**Additions and Renovations  
Platt Technical High School  
Milford, CT**

**ADDENDUM NO. 2**

July 29, 2019

**1 FIRST FLOOR PLUMBING PLAN AREA B**  
1/8" = 1'-0"

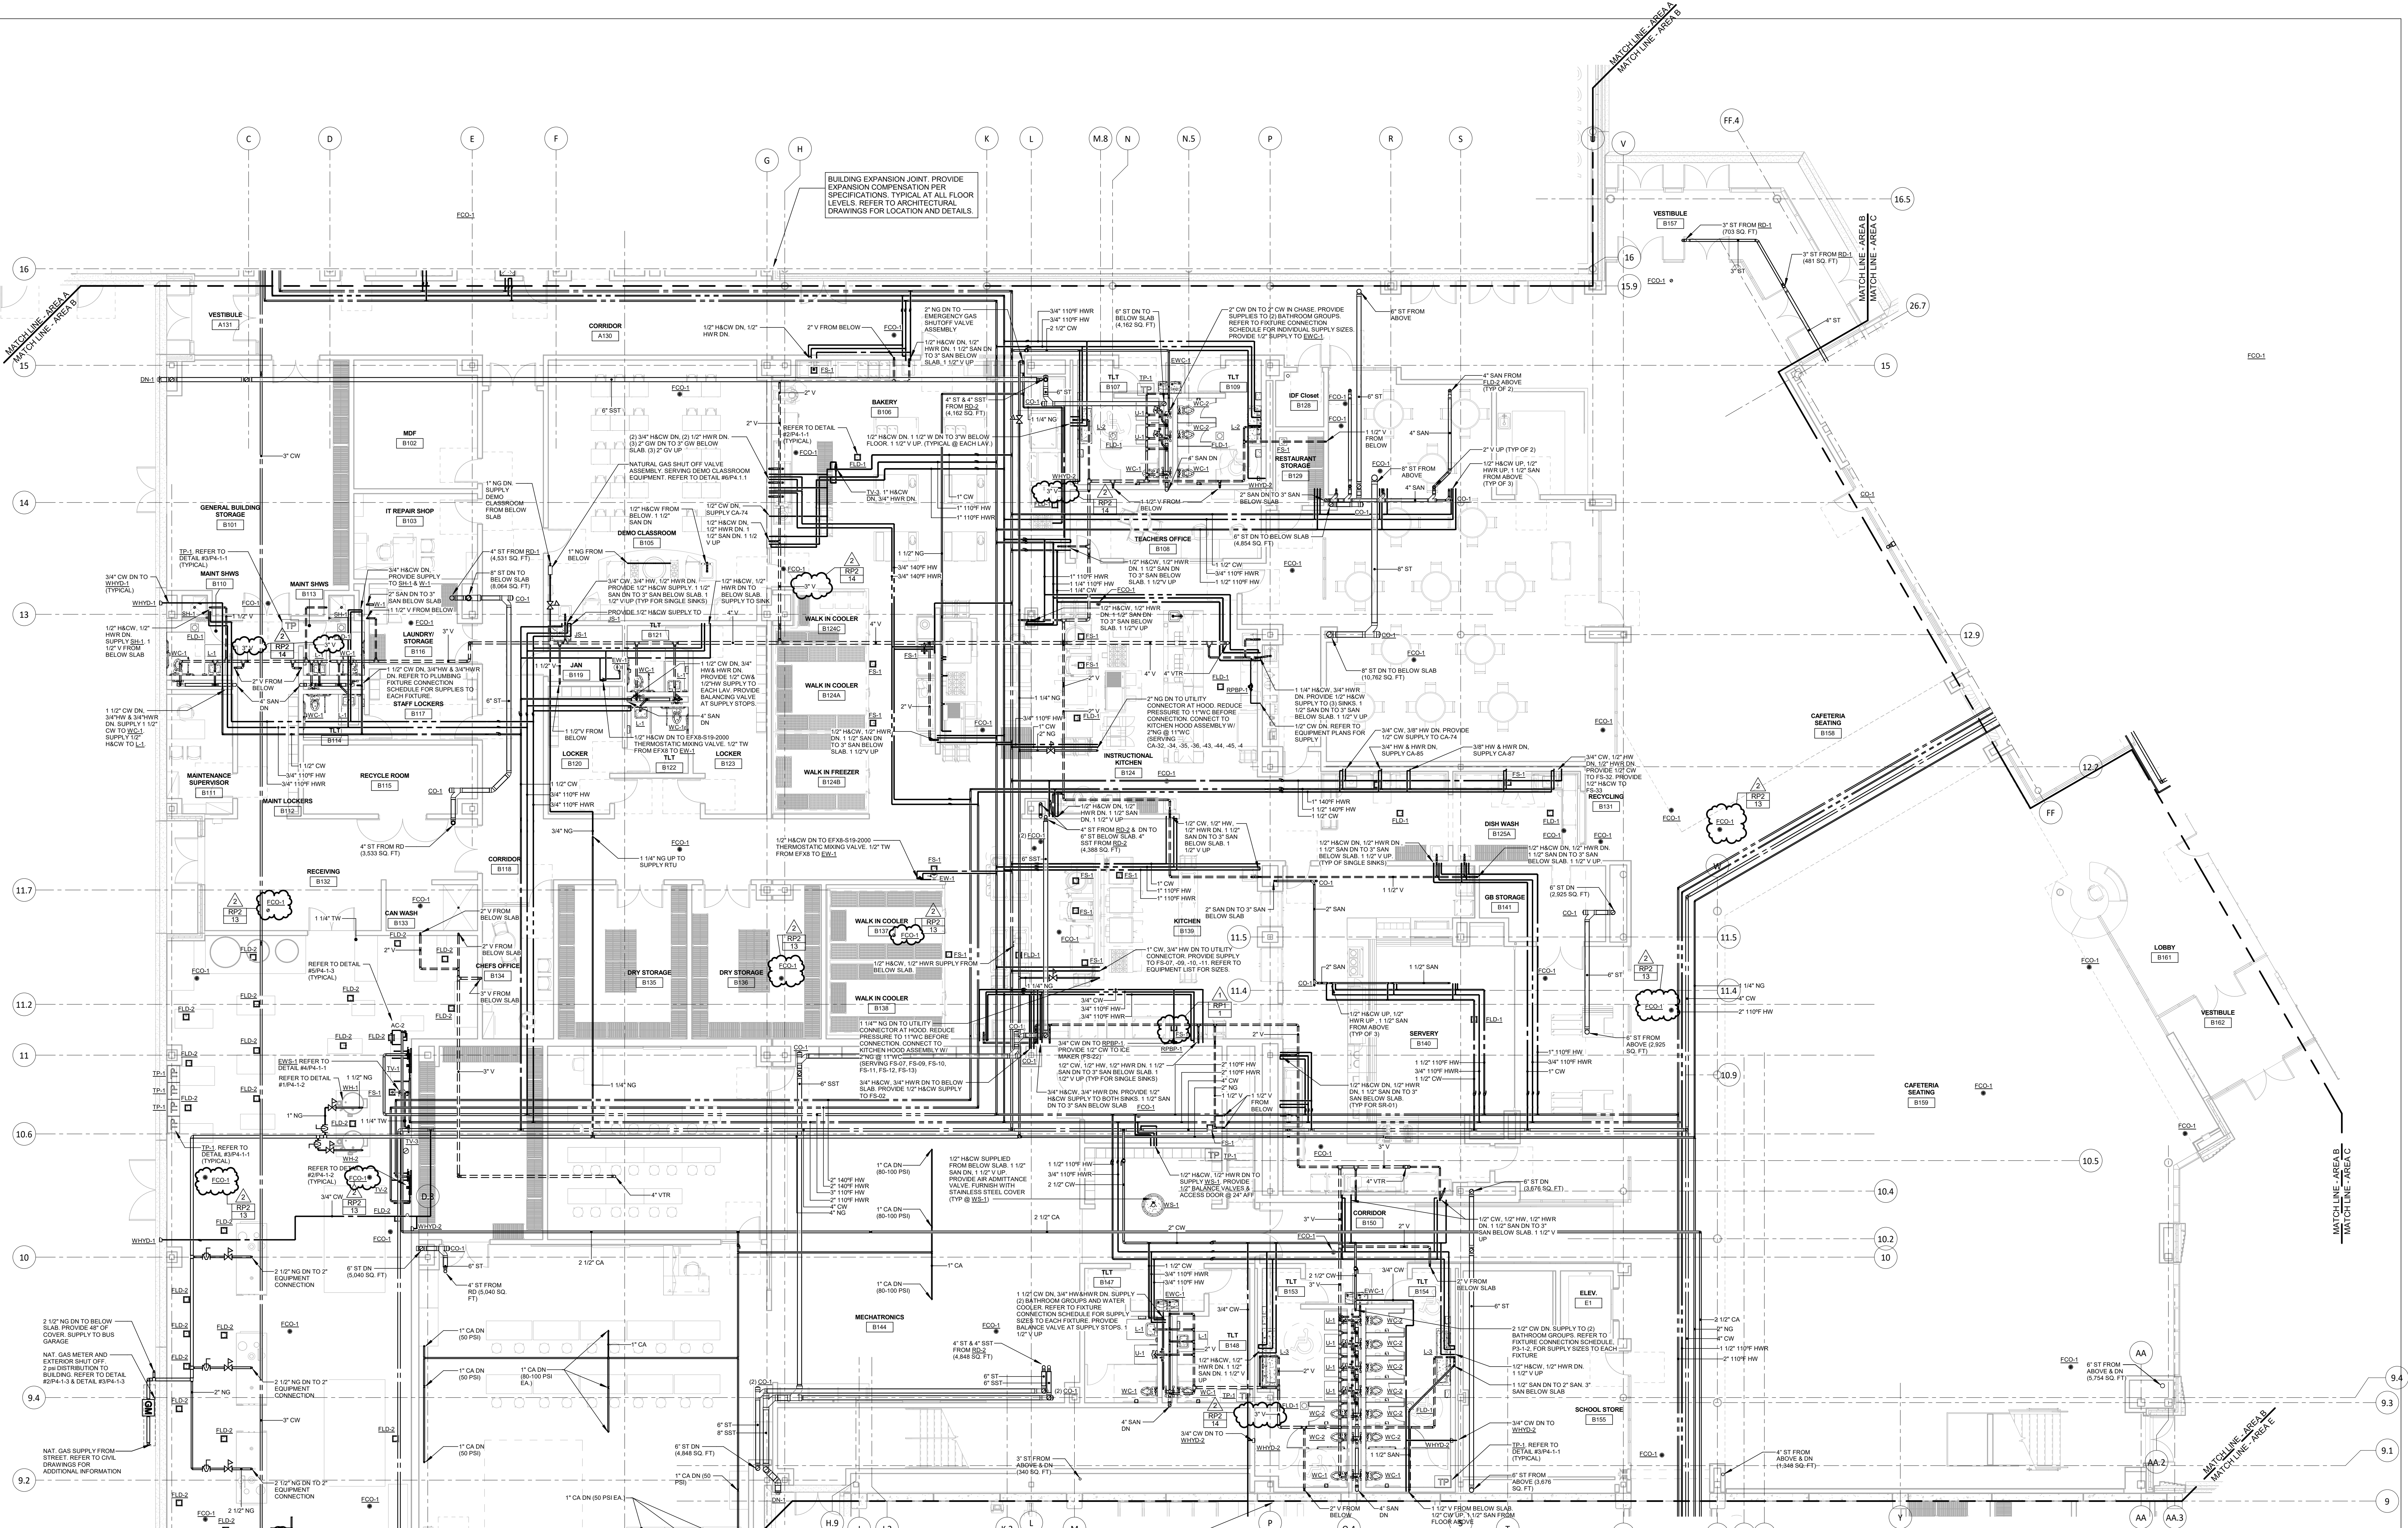
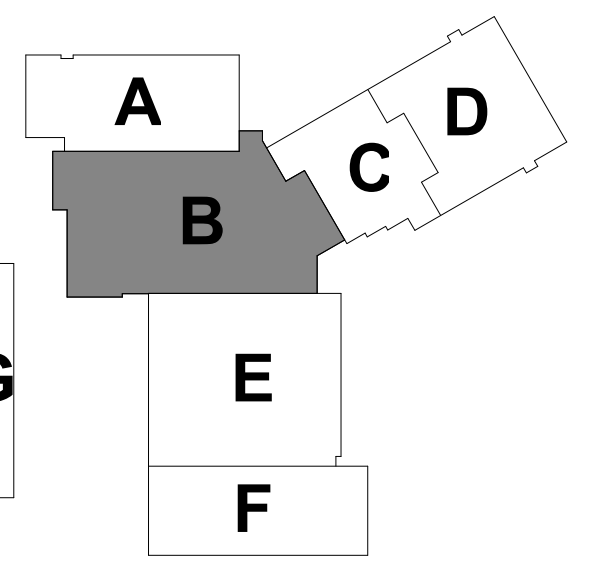
- ADD 2-027      DRAWING P1-1-1B – FIRST FLOOR PLUMBING PLAN – AREA B**  
Added floor clean outs (FCO-1). (SAME AS P1-1-UB) per Revision RP2-13.  
Modified vent piping from 2-1/2" to 3" per Revision RP2-14.

21.1  
1 FIRST FLOOR PLUMBING PLAN - AREA C  
1/8" = 1'-0"

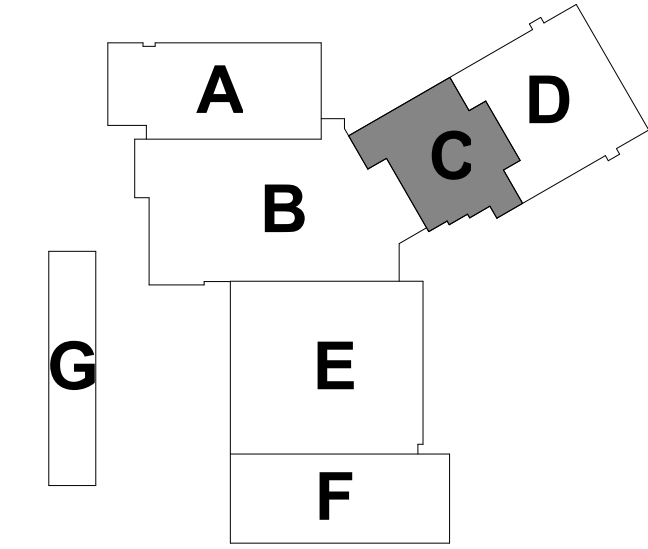
- ADD 2-028      DRAWING P1-1-1C – FIRST FLOOR PLUMBING PLAN – AREA C**  
Added floor clean outs (FCO-1). (SAME AS P1-1-UC) per Revision RP2-15.  
Modified vent piping from 2-1/2" to 3" per Revision RP2-16.

1 FIRST FLOOR PLUMBING PLAN - AREA D  
1/8" = 1'-0"

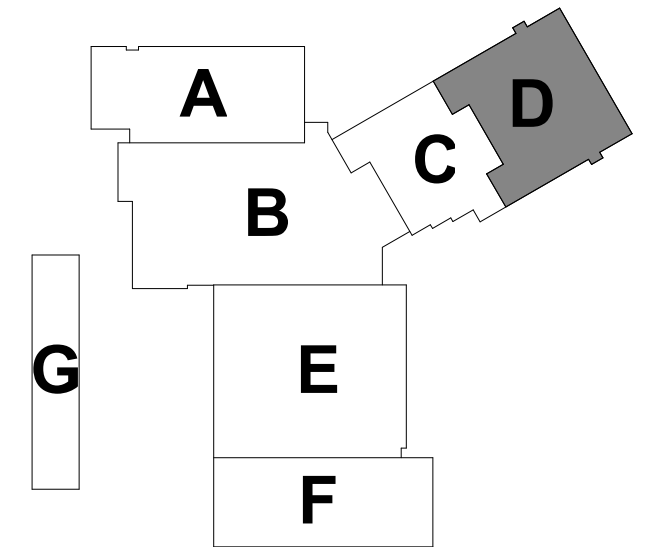
- ADD 2-029      DRAWING P1-1-1D – FIRST FLOOR PLUMBING PLAN – AREA D**  
Added floor clean outs (FCO-1) and piping. (SAME AS P1-1-UD) per Revision RP2-17.  
Added floor clean outs (FCO-2) and piping. (SAME AS P1-1-UD) per Revision RP2-18.  
Modified floor clean out tag (FCO-1 to FCO-2) per Revision RP2-19.  
Modified vent piping from 2-1/2" to 3" per Revision RP2-20.  
Added tag to 4" Acid Vent per Revision RP2-21.

1 FIRST FLOOR PLUMBING PLAN - AREA E  
1/8" = 1'-0"

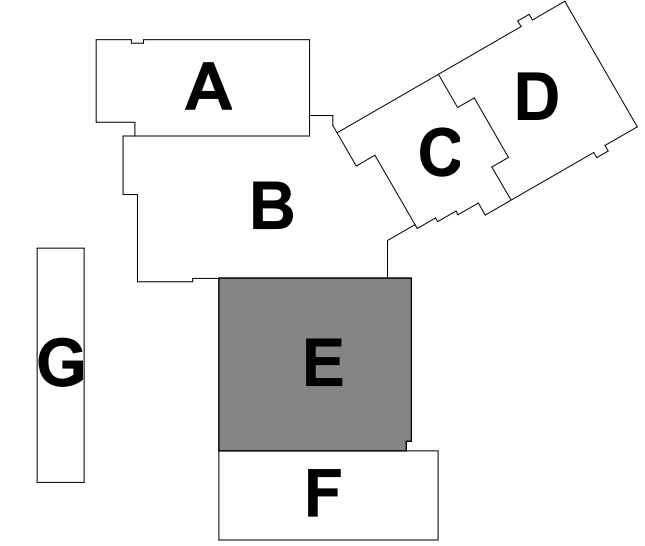
- ADD 2-030      DRAWING P1-1-1E – FIRST FLOOR PLUMBING PLAN – AREA E**  
Added floor clean outs (FCO-1). (SAME AS P1-1-UE) per Revision RP2-22.  
Modified vent piping from 2-1/2" to 3" per Revision RP2-23.

1 FIRST FLOOR PLUMBING PLAN - AREA F  
 1/8" = 1'-0"  
 SEE SF  
 REFER TO DRAWING PS-1-1 FOR PLUMBING LEGENDS.  
 REFER TO DRAWING PS-1-2 FOR SCHEDULES & FIXTURE CONNECTION SCHEDULE.  
 REFER TO DRAWINGS PA-1.1, PA-1.2 & PA-1.3 FOR PLUMBING DETAILS.

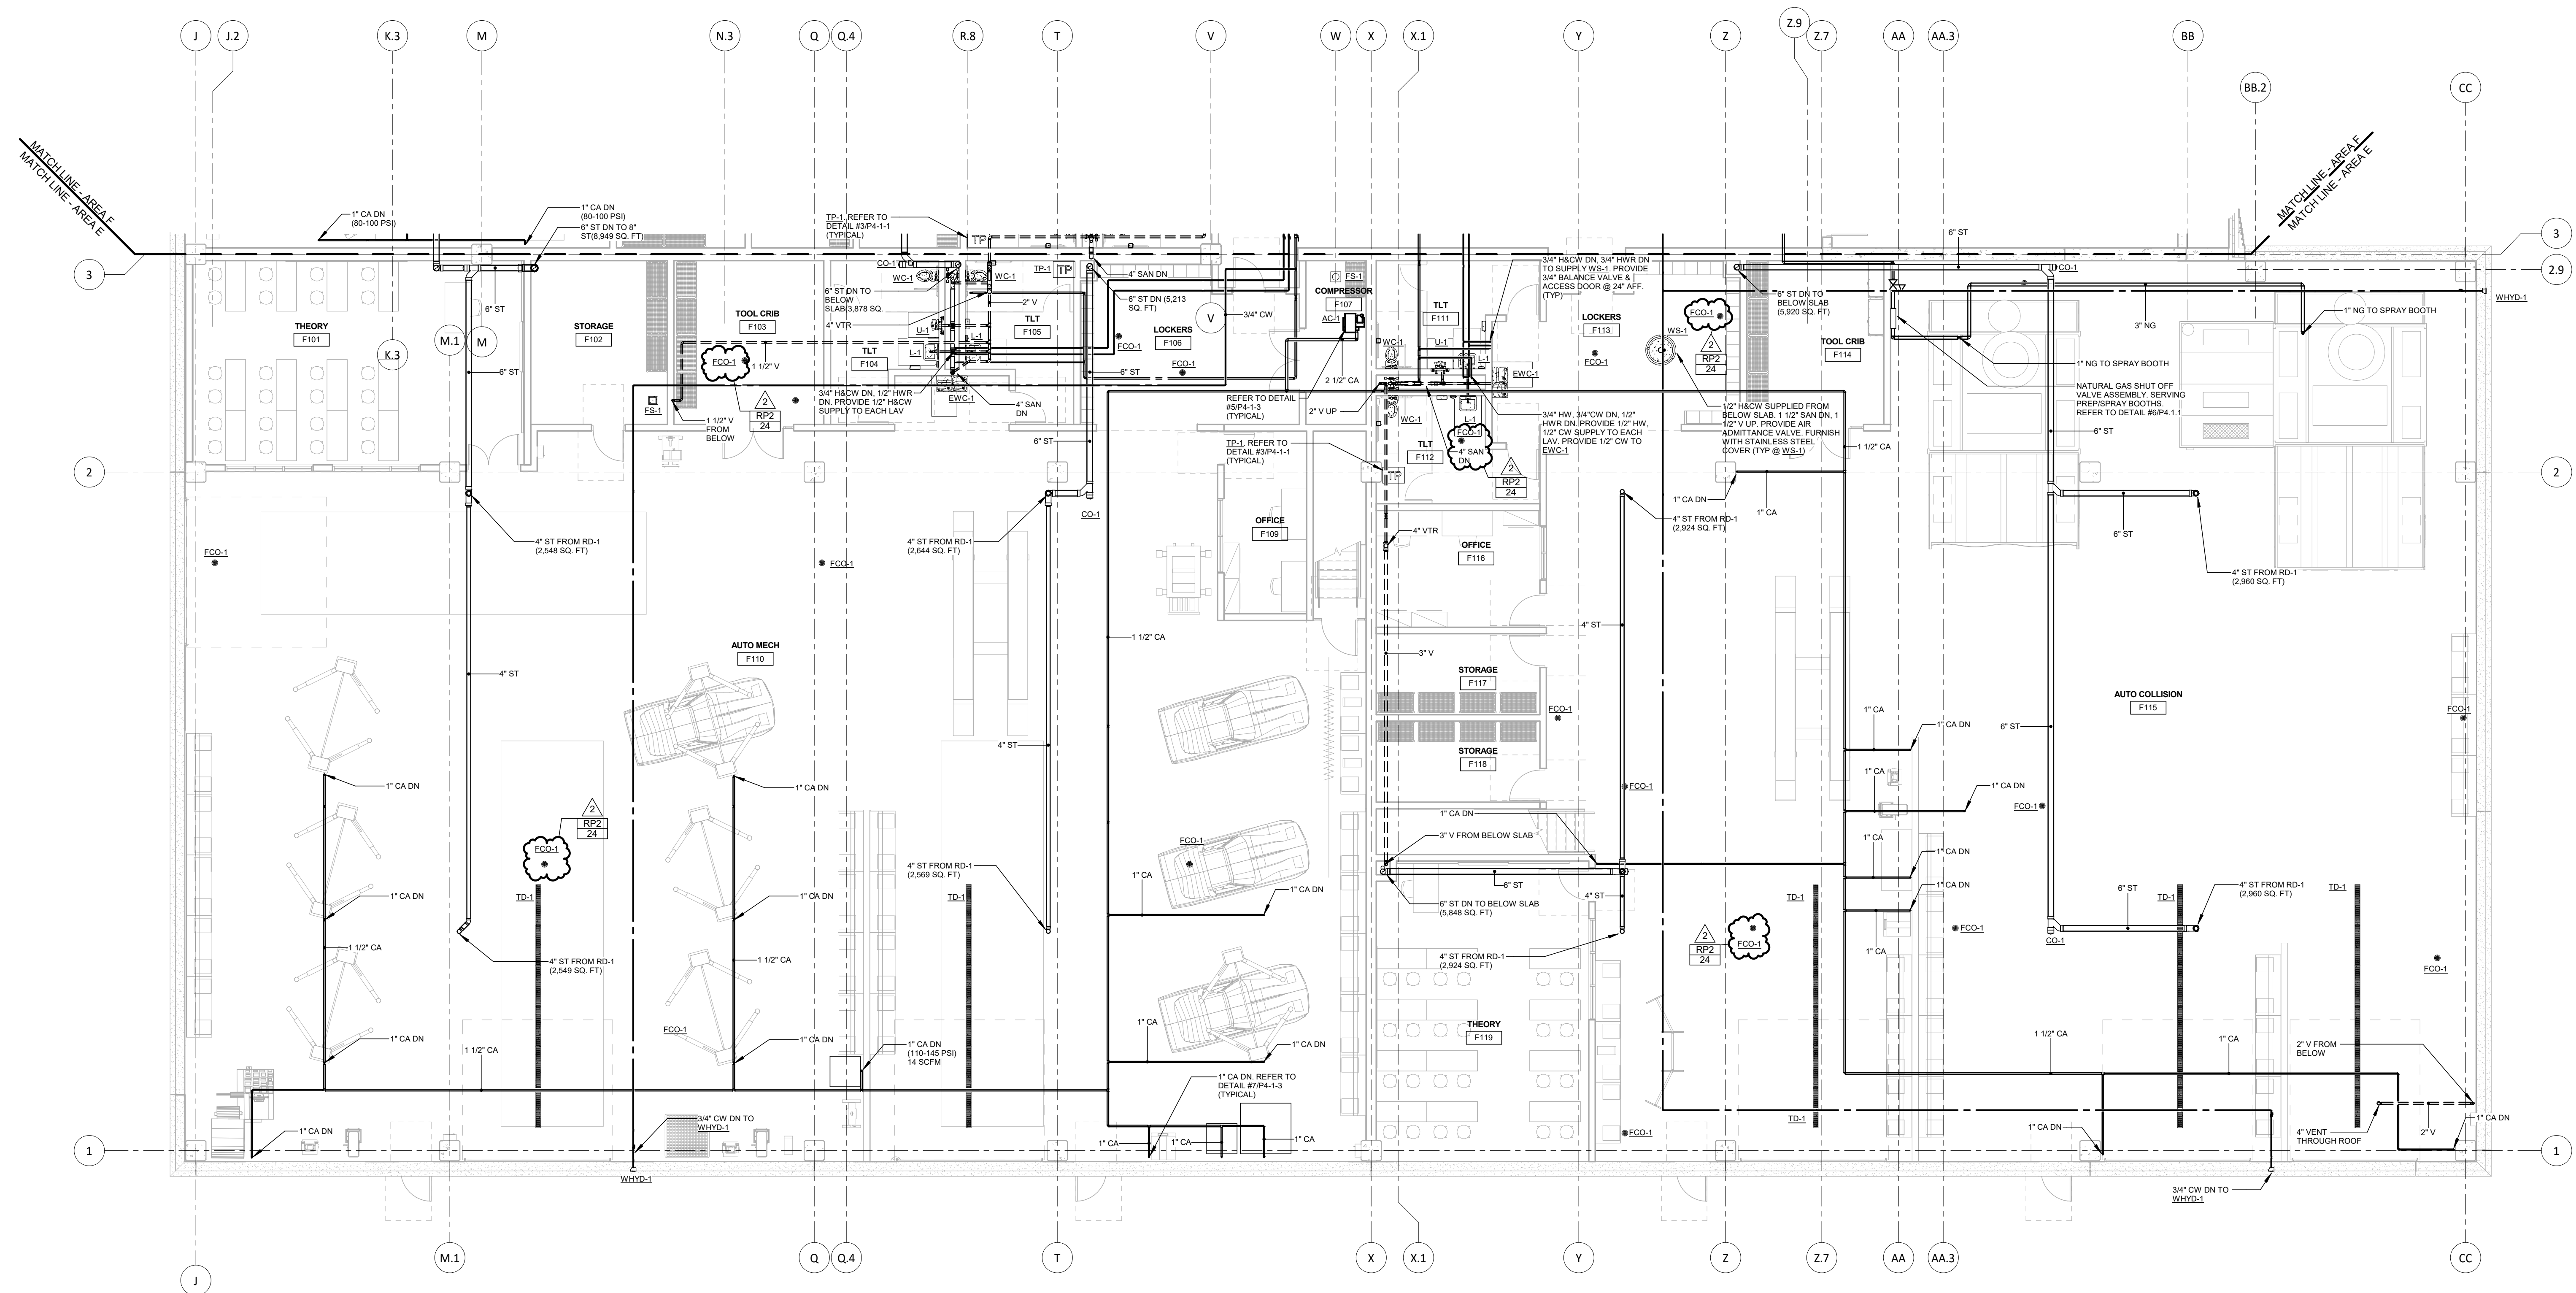
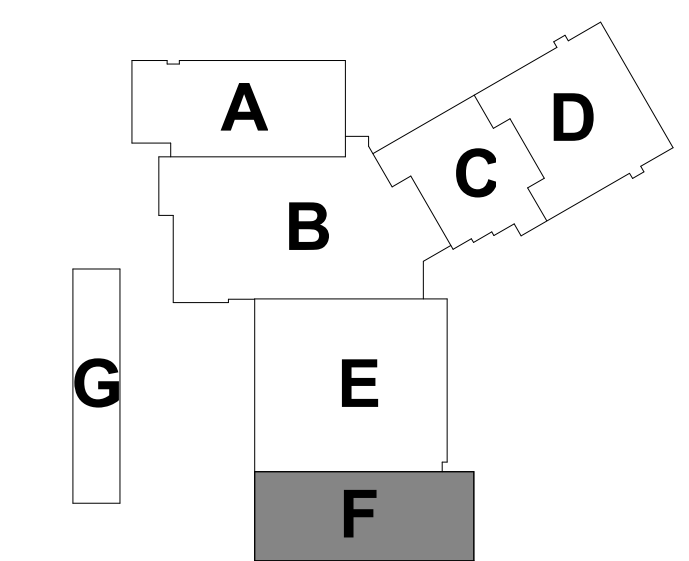
- ADD 2-031      DRAWING P1-1-1F – FIRST FLOOR PLUMBING PLAN – AREA F**  
Added floor clean outs (FCO-1). (SAME AS P1-1-UF) per Revision RP2-24.
- ADD 2-032      DRAWING P1-1-2B – SECOND FLOOR PLUMBING PLAN – AREA B**  
Modified vent piping from 2-1/2" to 3" per Revision RP2-25.

1 SECOND FLOOR PLUMBING PLAN - AREA C  
1/8" = 1'-0"

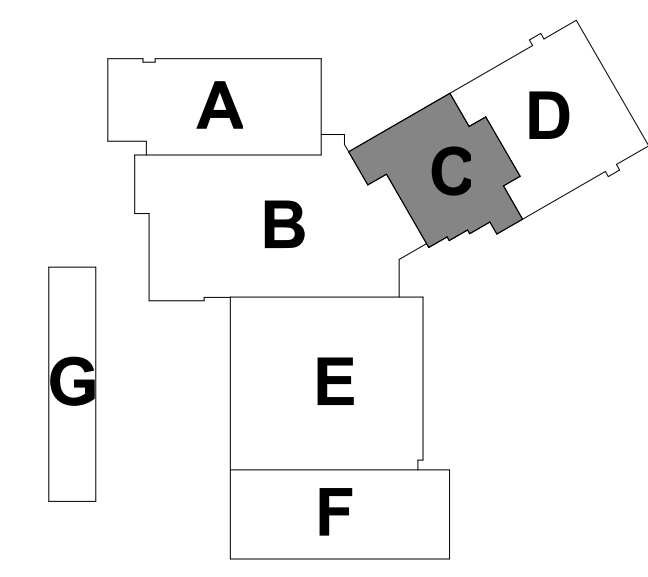
- ADD 2-033      DRAWING P1-1-2C – SECOND FLOOR PLUMBING PLAN – AREA C**  
Modified vent piping from 2-1/2" to 3" per Revision RP2-26.
- ADD 2-034      DRAWING P1-1-2D – SECOND FLOOR PLUMBING PLAN – AREA D**  
Modified vent piping from 2-1/2" to 3" per Revision RP2-27.
- ADD 2-035      DRAWING P1-1-2E – SECOND FLOOR PLUMBING PLAN – AREA E**  
Modified vent piping from 2-1/2" to 3" per Revision RP2-28.
- ADD 2-036      DRAWING P3-1-2 –PLUMBING ABBREVIATIONS, LEGENDS AND SCHEDULES**  
Modified remarks for FCO-1, FCO-2, WCO-1 per Revision RP2-29.
- ADD 2-037      DRAWING P4-1-2 –PLUMBING DETAILS**  
Modified TYPICAL OIL INTERCEPTOR INSTALLATION DETAIL to include flood level and additional notes per Revision RP2-30.
